October 1, 2015

**TO:** All U.S. Ford and Lincoln Dealers

**SUBJECT:** **Customer Satisfaction Program 15B25**  
Certain 2016 Model Year Lincoln MKX Vehicles  
Replace A-Pillar Trim Panels

FIGURE 1

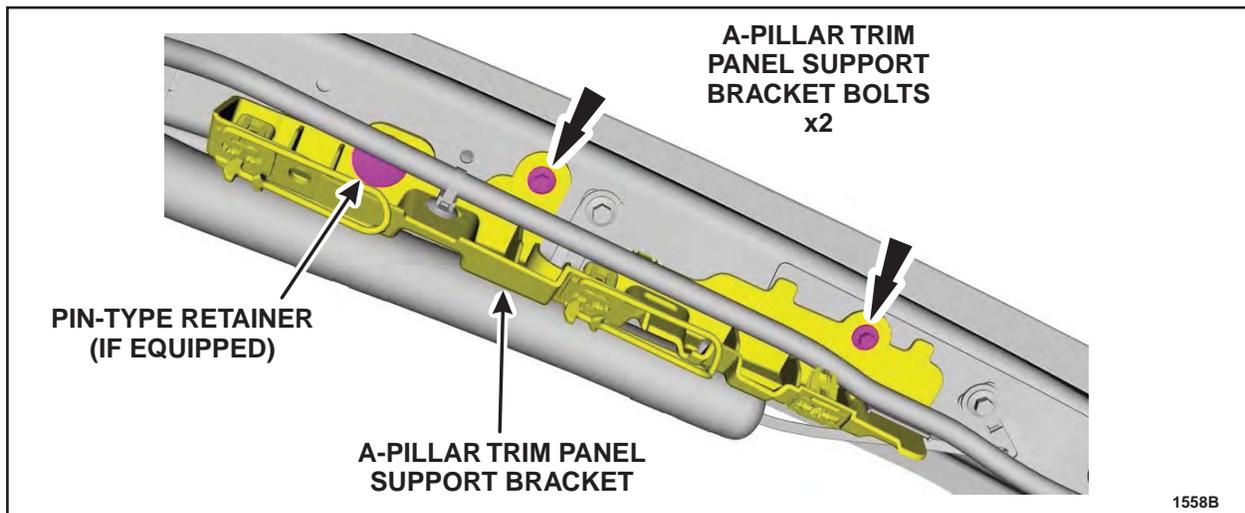
2. Remove the two bolts (and pin-type retainer on vehicles built after June 2, 2015) from the A-pillar trim panel support bracket. If equipped, discard the pin-type retainer. See Figure 1.

FIGURE 2

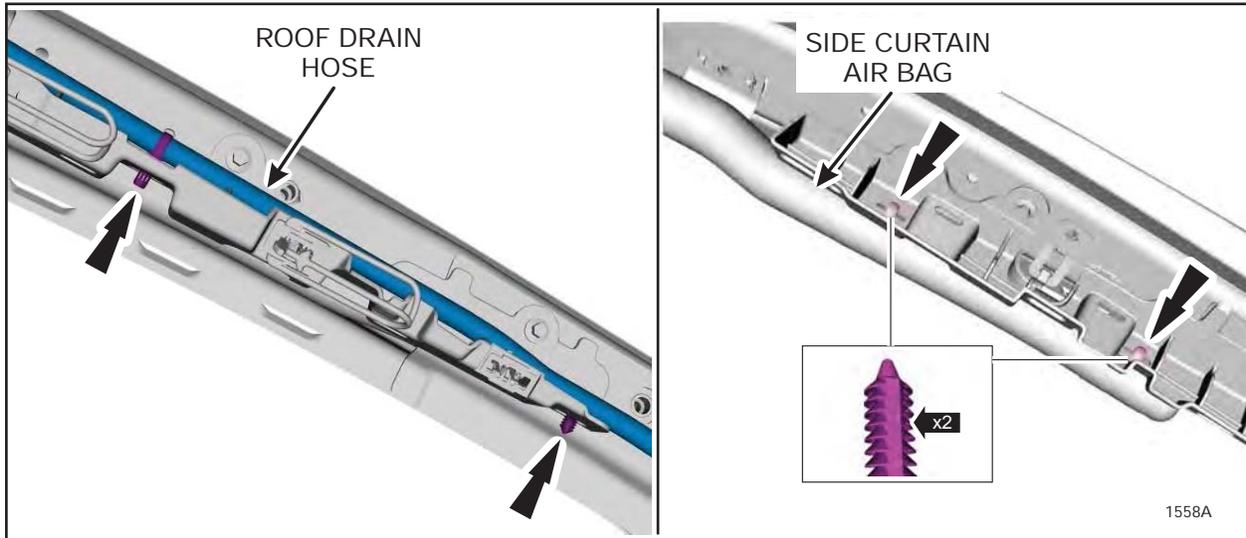
3. Disconnect the roof drain hose and side curtain air bag pin-type retainers from the A-pillar trim panel support bracket. Remove the A-pillar trim panel support bracket. See Figure 2.

FIGURE 3

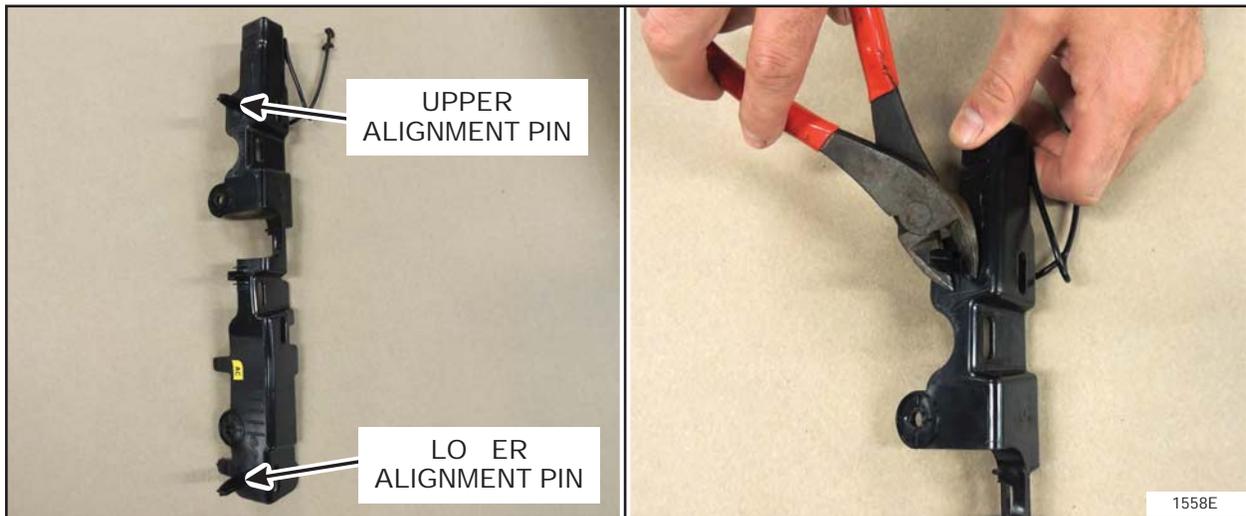
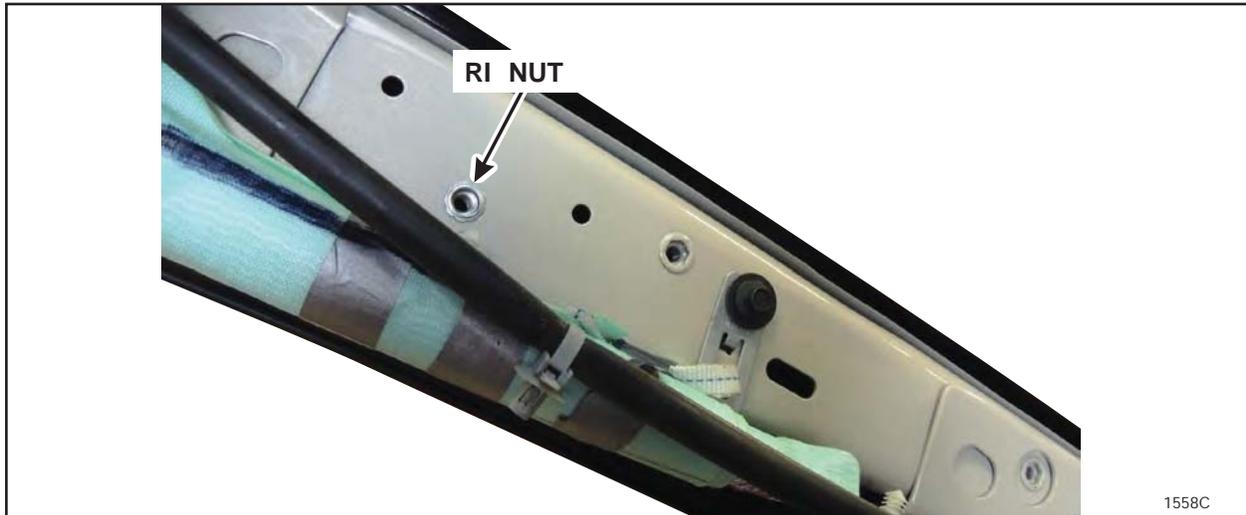
4. Cut the lower alignment pin from the A-pillar trim panel support bracket and file the surface until it is flush with the bracket. See Figure 3.
5. On vehicles built before June 2, 2015, cut the upper alignment pin from the A-pillar trim panel support bracket and file the surface until it is flush with the bracket. **At the upper alignment pin location only**, drill a hole centered on the previously removed alignment pin using a 17/64" (6.7 mm) drill bit. See Figure 3.

**FIGURE 4**

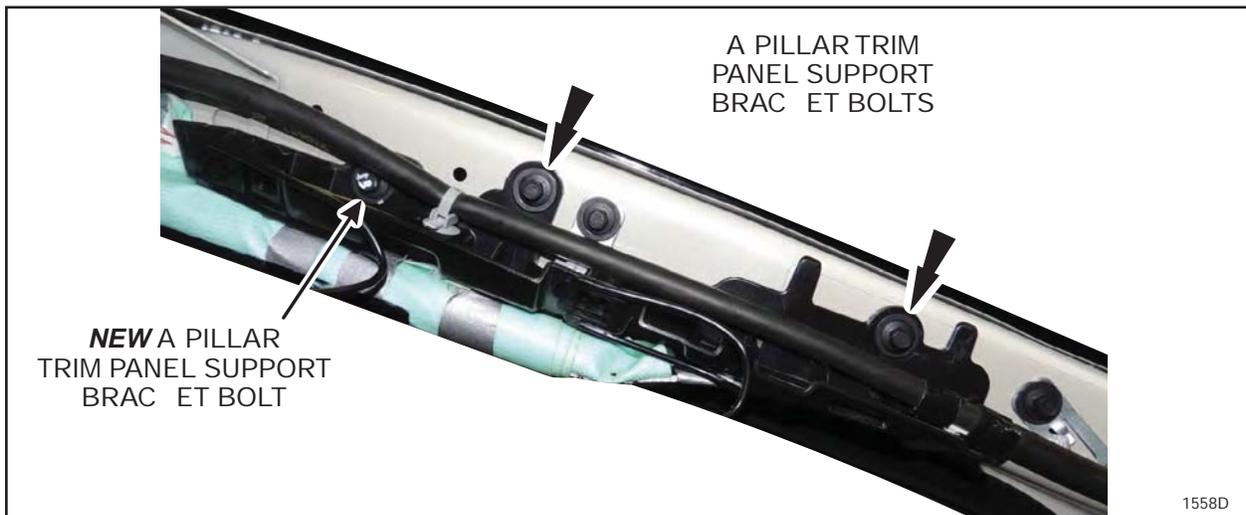
6. Install the Rivnut® into the upper A-pillar alignment hole using Rotunda Rivnut® installation tool AST1442 or equivalent. See Figure 4.
